**WPS1 - Checking Pressure Sensors and Replacing them if Necessary (Workshop Campaign)**

Vehicle Type: **Panamera 4 E-Hybrid (971) / Panamera 4S E-Hybrid (971)**

Concerns: **Air conditioning system pressure sensors**

*Installation position of pressure sensors*

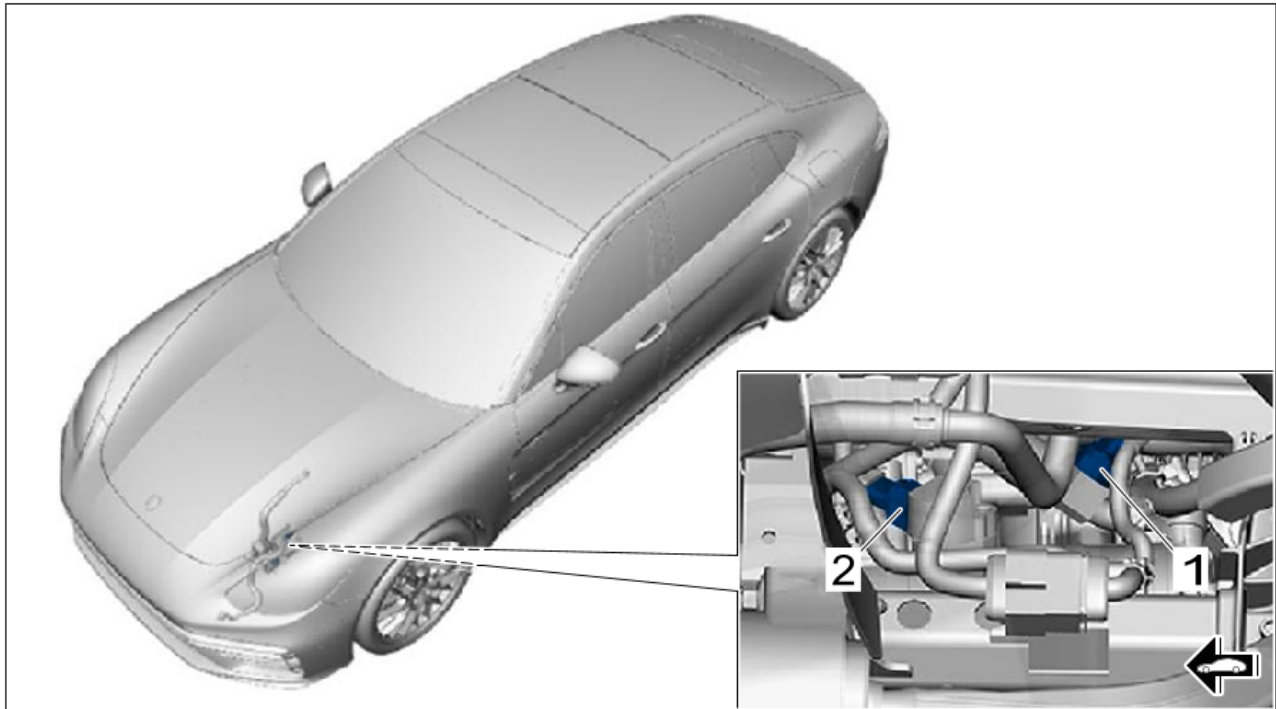
- 1 – Pressure sensor (PT1) on low-pressure side (**check and replace if necessary**)
- 2 – Pressure sensor (PT2) on high-pressure side (**check and replace if necessary**)

*New type of pressure sensor*

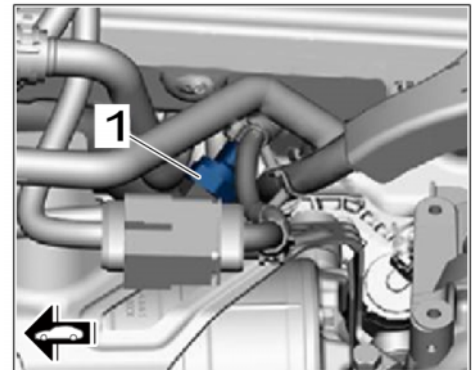
Pressure sensors with spare part number 4M0.959.603.**E** and applied production date:

- **up to** \_41921 are **not OK** and must be replaced.
- **from** \_42921 are **OK** and do **not** need to be replaced.

- 1 – Spare part index
- 2 – Production date from \_42921 (S / D / CW / YY - Shift / Weekday / Calendar Week / Year). Shown in the image: 1st place not relevant / weekday **6** / calendar week **08** / year**2022**

*Checking pressure sensor PT1*

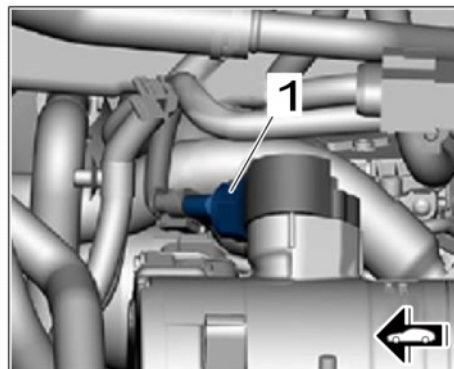
- 1 Check whether **pressure sensor PT1** corresponds to the new component status.

Assessment		Action
(x)	Pressure sensor with spare part number 4M0.959.603.C	Pressure sensors with spare part index <b>C</b> are <b>not OK</b> and must be replaced.  Replace the relevant pressure sensors. ⇒ Continue with Step 3 ⇒  [ Scope 10 to Scope 12]
(x)	Pressure sensor with spare part number 4M0.959.603.E and production date <b>up to_41921</b>	Pressure sensor is <b>not OK</b> due to production date (up to _41921) and must be replaced.  Replace the relevant pressure sensors. ⇒ Continue with Step 3 ⇒  [ Scope 10 to Scope 12]
(✓)	Pressure sensor with spare part number 4M0.959.603.E and production date <b>from_42921</b>	Pressure sensor is <b>OK</b> due to spare part index E <b>and</b> production date (from _42921) and does <b>not</b> have to be replaced.  <b>End of action.</b> Continue with ⇒ <i>Technical Information '400819 follow-up actions'</i>  [ Scope 9]
